Metal Bellows Accumulator Retrofit

Bulletin type: Service Information
Reference number: AFT.025.2022
Campaign reference: N/A
Attention: Retailer Aftersales Managers, Retailer Service Managers, Retailer Service Advisors, Retailer Technicians, Retailer Parts Managers
Affected vehicles: McLaren 720s – Coupe and Spider built pre-May 2021
Situation: Updated parts are available where applicable. Please refer to the information outlined in this document
Procedure: Action the information contained in this bulletin to complete the metal bellows accumulator retrofit
Date: 16th June 2022

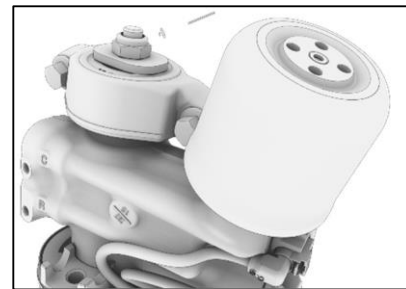
McLaren Automotive is pleased to announce that updated suspension accumulators are now available for 720s Coupe and Spider vehicles that were built before May 2021. Post-May 2021, all McLaren 720s Coupe and Spider vehicles were built with the updated metal bellows accumulators. The introduction of metal bellows accumulators for earlier vehicles will bring the benefit of increased longevity in comparison to the earlier membrane accumulators. This bulletin will provide information on the parts required in all circumstances, the Service Information System (SIS) instructions applicable and repair advice.

Earlier Membrane Accumulator

New Metal Bellows Accumulator

4. Repair Advice

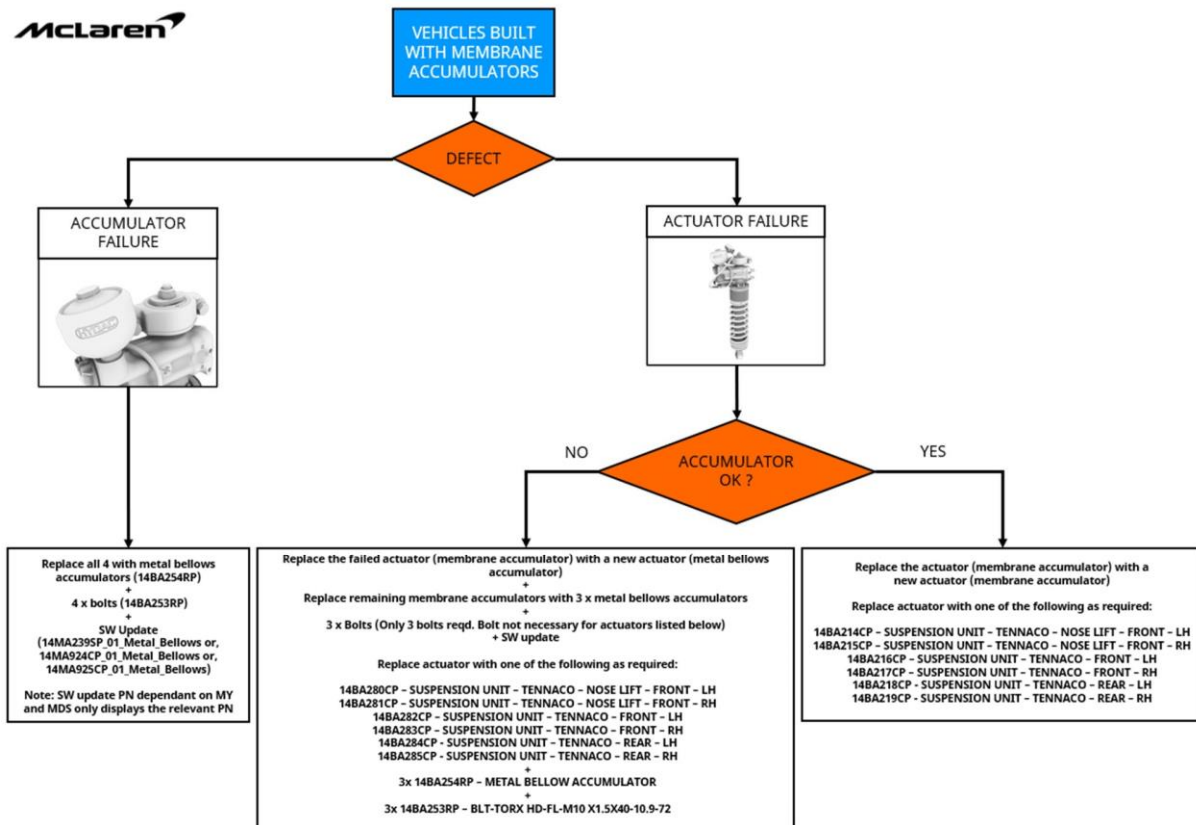
Please see the flow chart below for the advised repair actions based on the customer complaint followed by correct diagnosis of the fault. While the flow chart below represents the repair advice in the event of a fault, the customer is of course able to pay for the full Metal Bellows Accumulator Retrofit at any time to realise the benefits.
